VAN DEURZEN AND ASSOCIATES, P.A.
CONSULTING STRUCTURAL ENGINEERS
11011 KING STREET, SUITE 130
COMMERCE TERRACE BUILDING D
OVERLAND PARK, KANSAS 66210
(913) 451 - 6305 FAX (913) 451 - 1021

Re: 1505 SW Heartwood - Deck Framing Evaluation Report
Lee's Summit, MO
Bldg. Permit No.: PRRES20235231

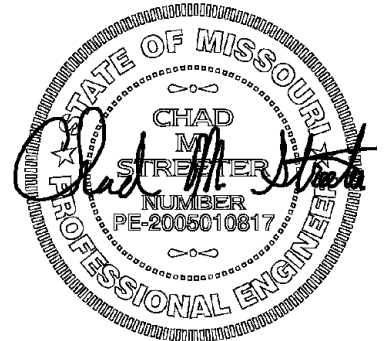
In accordance with your request, an inspection of the deck framing for the above mentioned residence was performed by our office. At the time of our inspection, the deck framing had been completed. We had noted that the deck header was framed with a triple 2x12 header and was fastened to the upper and lower 6x6 post with a minimum of four LedgerLOK screws which were toe-screwed from the top of the lower post to the header and from the bottom of the upper post to the header. The posts were anchored to the footing with a standoff post base.

Based on our inspection, the deck had been framed in general conformance with the permit drawings and the upper and lower posts had been adequately fastened to the deck framing to resist the uplift loads. We did not note any deviations which required correction.
